**TOWNSHIP OF VERONA
BOARD OF ADJUSTMENT APPLICATION**

Re: Zoning Letter of Denial

Owner: Mr. Daniel and Mrs. Dana Zarfino
Applicant 48 Kenwood Avenue
Verona, NJ 07044
Property: 48 Kenwood Avenue
Lot 42 Block 1503
Zone: R-50B (Medium High Density)

- Township of Verona Zoning Permit Application.
- Engineering Plans Entitled "Pool Location and Grading Plan for the Zarfino Residence" prepared by DJ Egarian & Associates Inc. Plans dated 01/20/22 and last revised 01/31/22. Sheet No. 1 of 1.

POOL LOCATION & GRADING PLAN

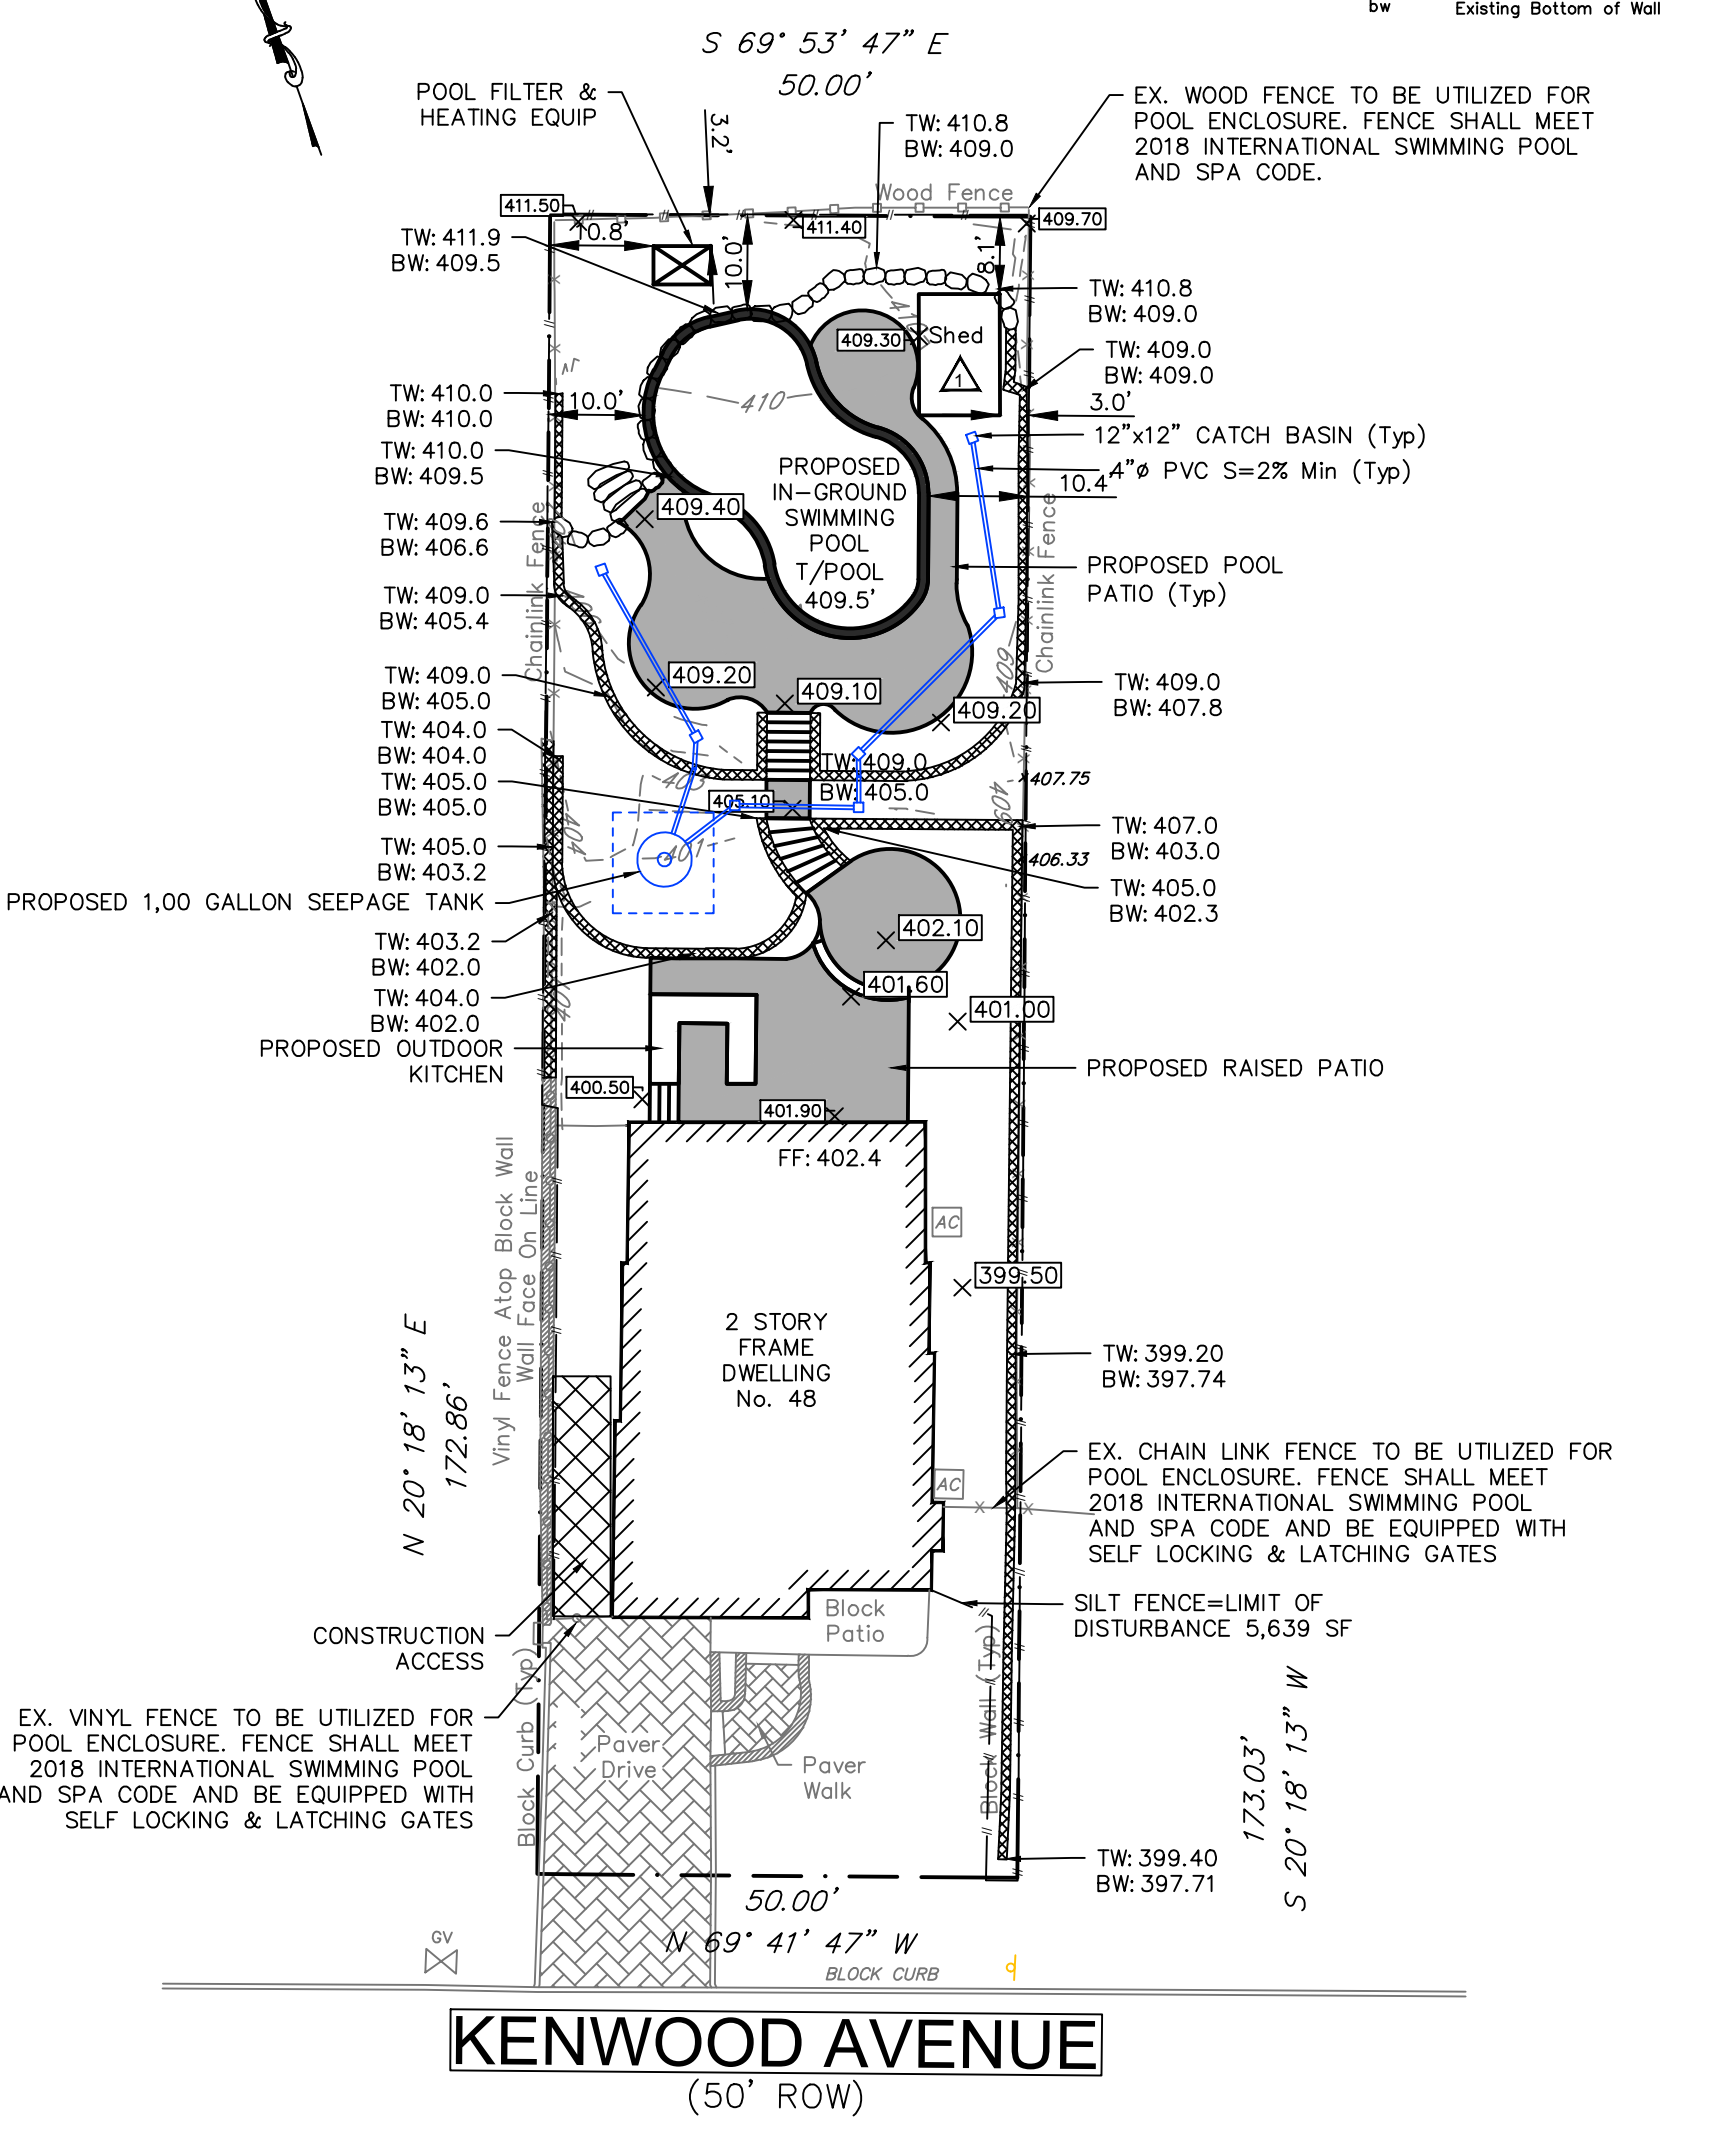
Based upon the zoning permit application and the plans submitted we understand that the owner/applicant is seeking approval from the zoning and engineering department demolish a majority of the rear yard area. The proposed plan calls for the relocation of the existing shed (106 ± sq.ft.) from the left rear corner to the right rear corner of the property. The applicant is seeking approval to construct an in-ground swimming pool, multiple retaining walls, patio sun deck, and fire pit sitting area and an outdoor kitchen on a raised patio.

The plans only show elevation topography within the area of work (rear yard). The natural grade slopes from the rear property line towards the dwelling at roughly 10½ percent and has a natural cross slope from right to left of approximately of roughly 10 percent as well (Excluding exist. walls). The rear yard is leveled off by means of a series of walls which terrace off the uppermost area and then terrace down from there to the home. This property is exempt from the regulatory constraints of the Townships Steep Slope Ordinance based on the zone it is in.

- The applicant's plans indicate the use of multiple walls each not to exceed 4 feet in vertical height

- The existing/proposed shed which is scheduled to be relocated is 106 sq.ft.

- The existing maximum improved lot coverage is: 34%
- The proposed maximum improved lot coverage is 50.6%

- The existing shed is 3.2 feet.
- The proposed shed is 3.2 feet (relocated)

- The existing shed is currently 9.5 feet.
- The proposed shed is 8.1 feet (relocated)

- The total area of the "rear yard": 1,500 ± sq.ft.
- The existing total area covered by accessory structure: 246 ± sq.ft. = 16%
- The proposed total area covered by accessory structure: 763 ± sq.ft. = 50%

- 10.0 feet proposed
Required Swimming Pool Setback to a Rear Yard 10 (Feet)
- 10.0 feet proposed.
Required Swimming Pool Setback to a Principal Bldg. 10 (Feet)
- 50 ± feet proposed.
B. All Filtration Equipment shall be located not less than 5 feet from a property line.
- 3.2 feet proposed.

§150-17.4 D. (4) Exceeds maximum improved lot coverage: 40% permitted, 50.6% proposed.

§150-17.4 F. (1) Shed does not meet minimum side yard setback (one): 8 feet required, 3.2 feet proposed.

§150-17.5 F. (2) Shed does not meet minimum rear yard setback: 10 feet required, 8.1 feet proposed.

§150-17.4 F. (4) Exceeds maximum aggregate area covered by accessory structure(s) in the yard it is Located: 15% permitted, 50% proposed.

6. The applicant's plans which were reviewed **DO** indicate that the anticipated work calls for the removal of several trees. The Township allows permission for the removal of trees **ONLY** under the conditions per Chapter 493 of the Municipal Code. The exact number of tree to be removed and how those trees are to be mitigated for should be presented to the Board and included as part of any condition(s) of their approval.

8. Any retaining wall in excess of 4 feet in vertical height will require that structural stability calculations be submitted to the engineering and building department for review and approval prior to any work being performed.

9. It appears that the existing grade in the rear yard area is being raised by more than 6 inches. The applicants engineer or contractor must submit to the engineer/zoning office a letter which indicates where the fill material is coming from and a letter that certifies that it is "clean fill". Recycled aggregate(s), construction debris and organic material(s) of any kind are not permitted as fill.
